FINAL ENVIRONMENTAL IMPACT REPORT

VAN DER KOOI DAIRY

November 2007

Lead Agency: San Joaquin Valley Air Pollution Control District
1990 East Gettysburg Avenue
Fresno, California 93726-0244

<p>Quad Knopf</p>	<p align="center">Locations of Important Biological Resources</p>	<p align="center">Figure A</p>
--	--	---------------------------------------

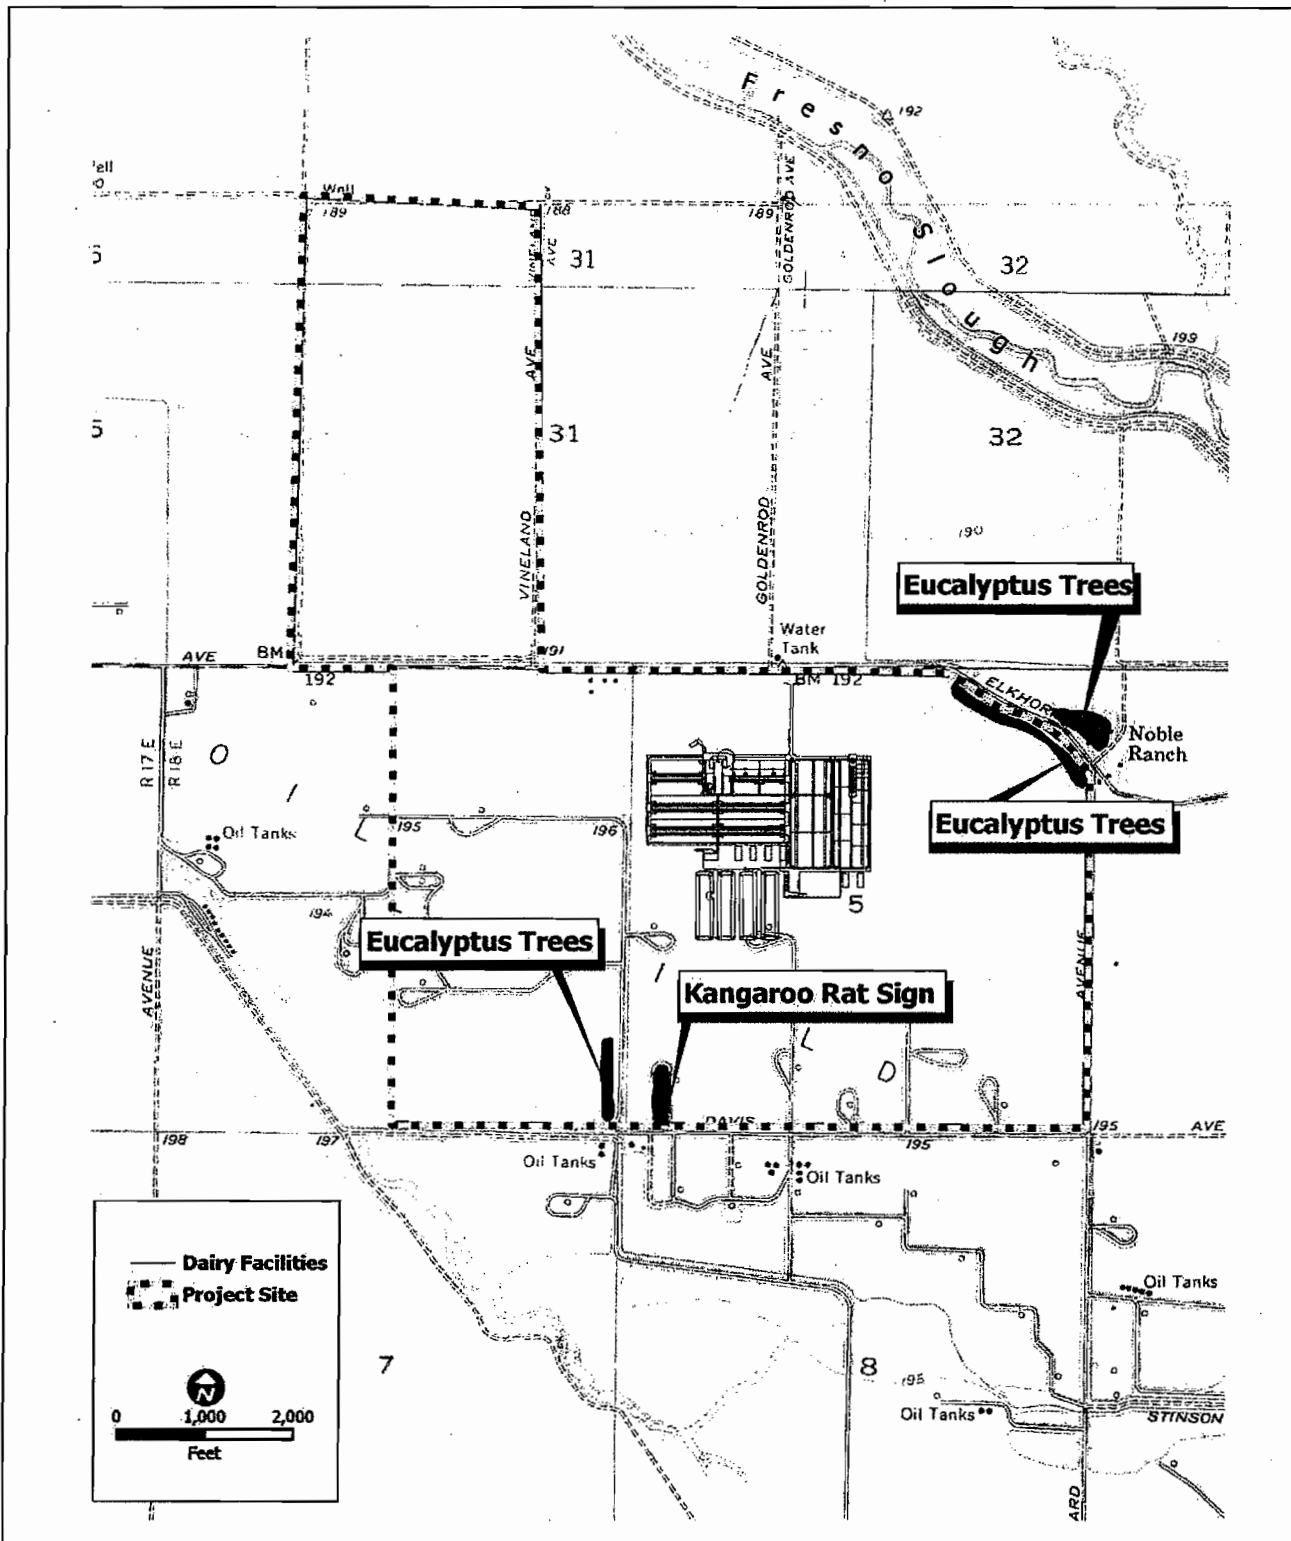
Comment 4-5: Fresno Kangaroo Rat (FKR): *The DEIR mentions that kangaroo rat sign (burrows, tail drags and scat) was found on an oil well pad within the Project area; however, trapping was not conducted to determine the species of kangaroo rat on site. The Department recommends that trapping be conducted by a permitted biologist to determine if the state and Federally endangered FKR is within the Project area. The oil well pads, roads and a 100 foot buffer around these areas should be surveyed. Since construction has already begun, trapping should be conducted immediately to determine the species of kangaroo rat on site. If a KFR is trapped in these areas, construction and dairy operation should stop and consultation with the Department should occur.*

Response 4-5: The recommendation is noted.

1. Agricultural operations must not encroach into the existing oil well pad sites;
2. Agricultural activities within 0.25 miles of the kangaroo rat occurrence (see Figure A) shall not be conducted after sundown (kangaroo rats are active at night);
